WILLIAMSON COUNTY, TEXAS

CHANGE ORDER NUMBER: 3

Project: 1604-075

Roadway: CR 110 South

LOW PROFILE CONCRETE BARRIER PRECAST BARRIER (TYPE 1) LPCB-13

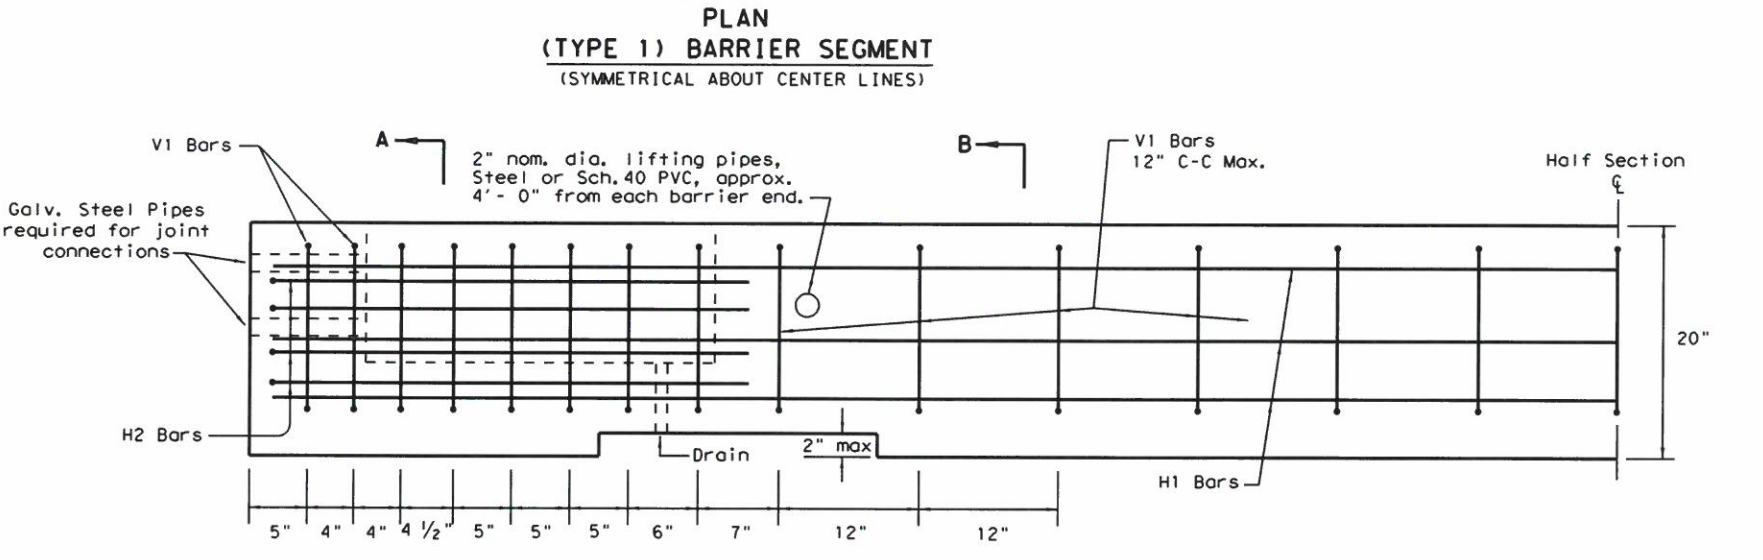
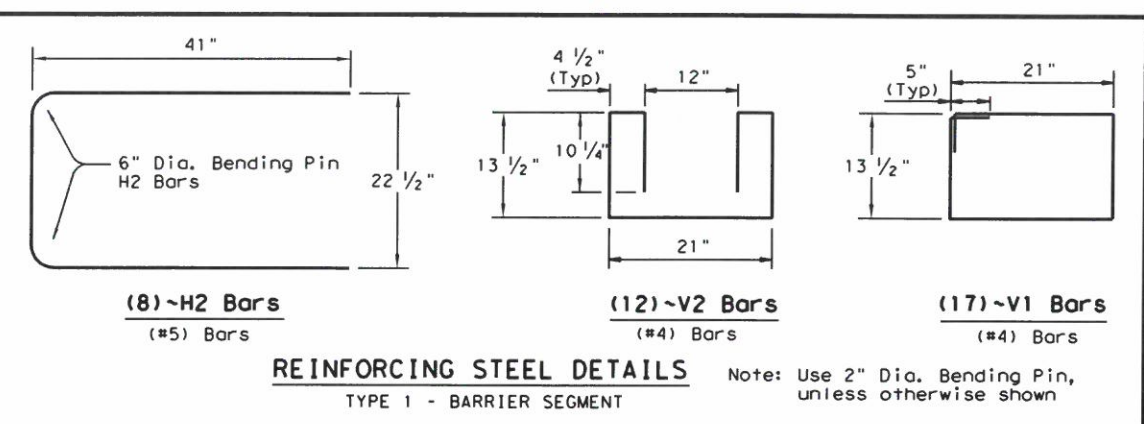
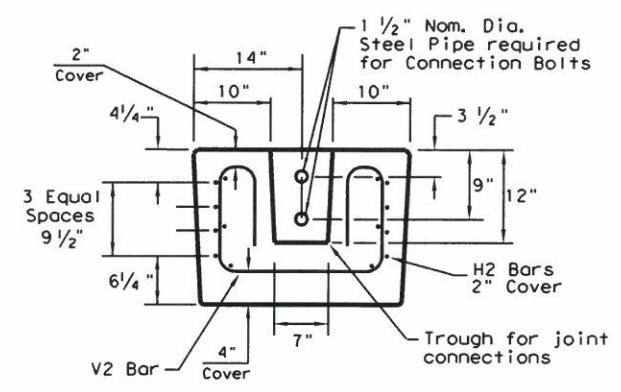
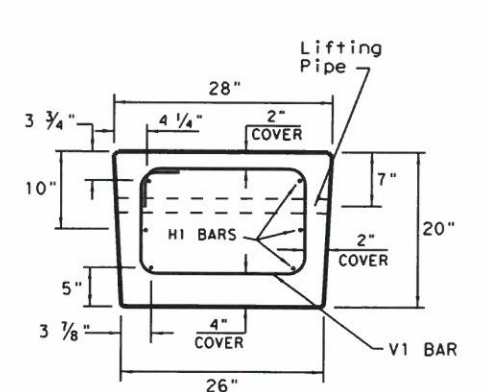
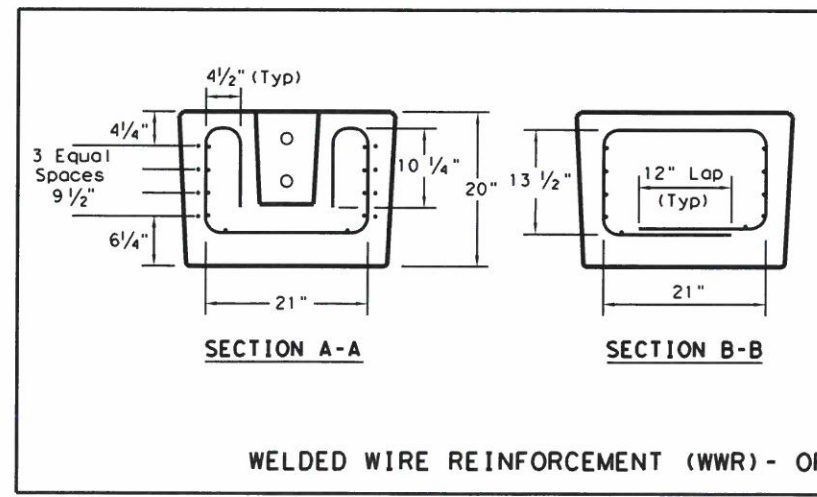
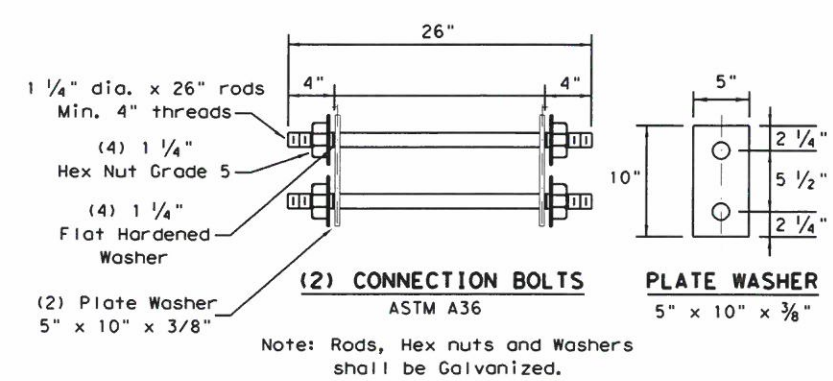
This Change Order also substitutes the Portable Single Slope Concrete Traffic Barrier (SSCB) with Low Profile Concrete Traffic Barrier (LPCB). The posted speed limit is 45 mph, which is the maximum speed limit allowed for use of LPCB. This will provide cost savings to the project and expedite construction.
